August 15, 1984

HOPE CREEK GENERATING STATION
DOCKET NO. 50-354
FSAR CHANGES RESULTING FROM LICENSEE QUALIFICATIONS BRANCH
MEETING JULY 23, 24, AND 25, 1984

Attached are copies of the modifications to FSAR Chapter 13
and Section 1.10, listed below, which were discussed at the
NRC/PSE&G Licensee Qualifications Branch meeting held
July 23, 24, and 25, 1984:

FIGURE ISJ - 6A

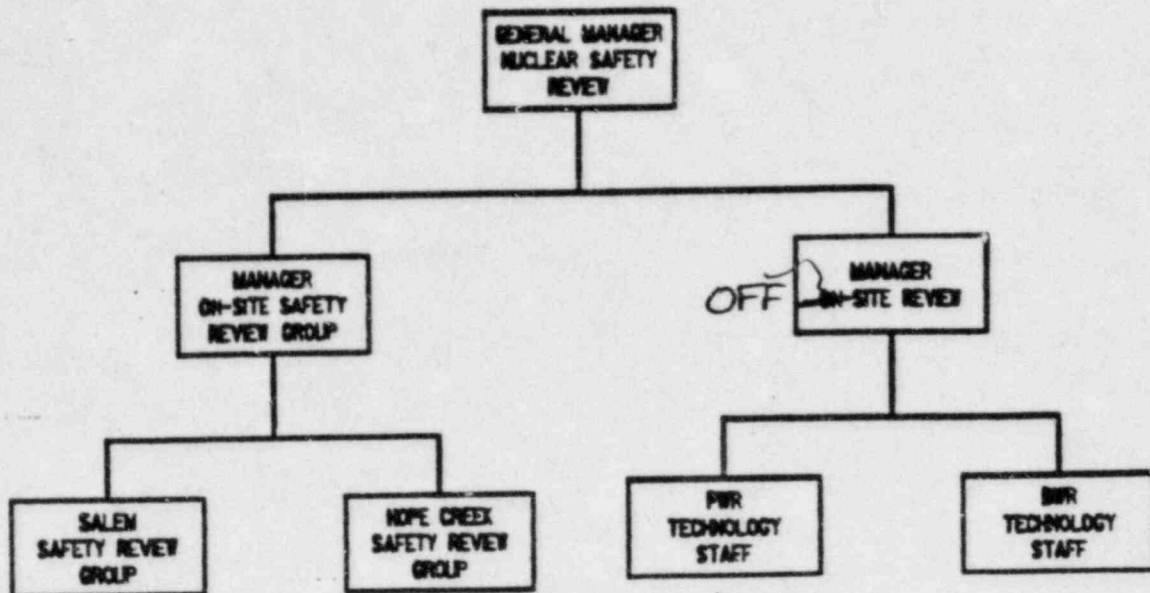
- (1) FSAR Section 13.4 - Review and Audit
- (2) FSAR Table 13.1-4 - Resumes of Managerial and Supervisory Staff Hope Creek Operations
- (3) FSAR page 1.10-3
- (4) Minor revisions and one additional resume for FSAR Table 13.1-1a
- (5) Correction to FSAR Figure 13.1-6a
